MIDTOWN COLLECTION AT HANNAH RIDGE FILING NO. 3

OVERLOT GRADING & EROSION CONTROL PLAN

EGP-20-007

MIDTOWN COLLECTION AT HANNAH RIDGE
 FILING NO. 3
 OVERLOT GRADING AND EROSION CONTROL PLAN

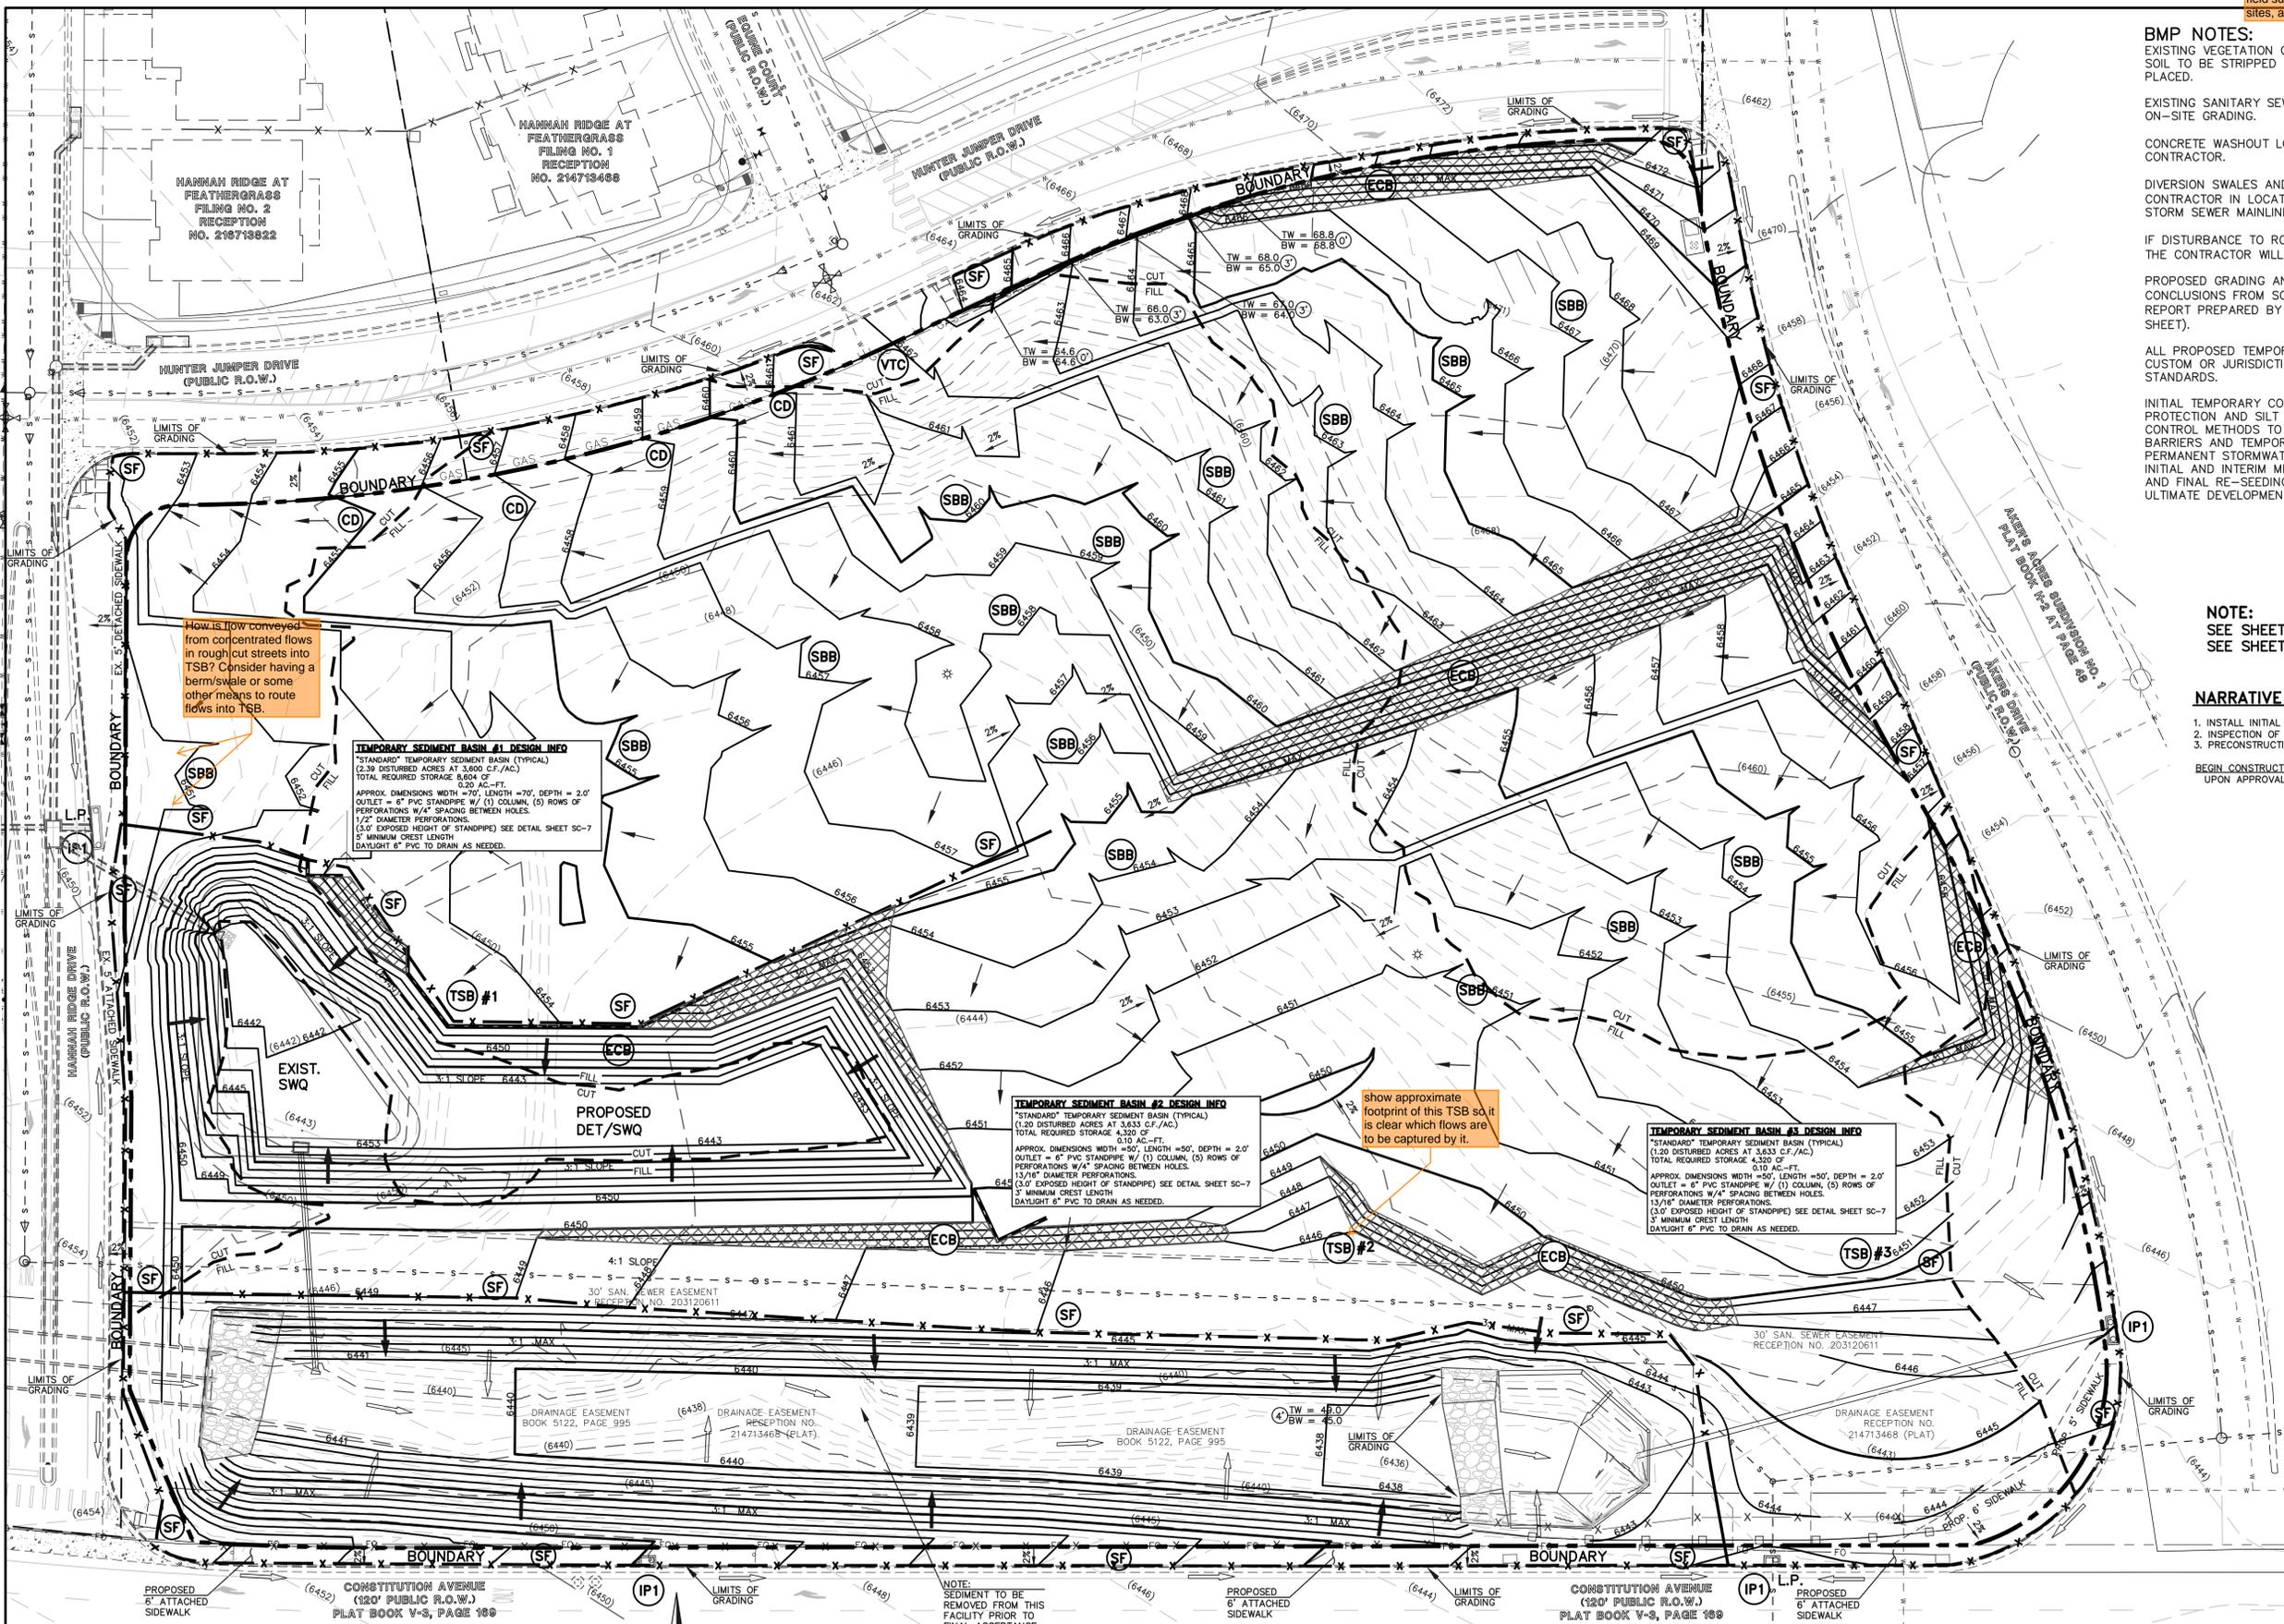
Add some text like: "developer/contractor to decide locations in the field such the concentrated flows will be prevented from exiting the sites, and rather directed towards TSB's."

How is flow conveyed from concentrated flows in rough cut streets into TSB? Consider having a berm/swale or some other means to route flows into TSB.

show approximate footprint of this TSB so it is clear which flows are to be captured by it.
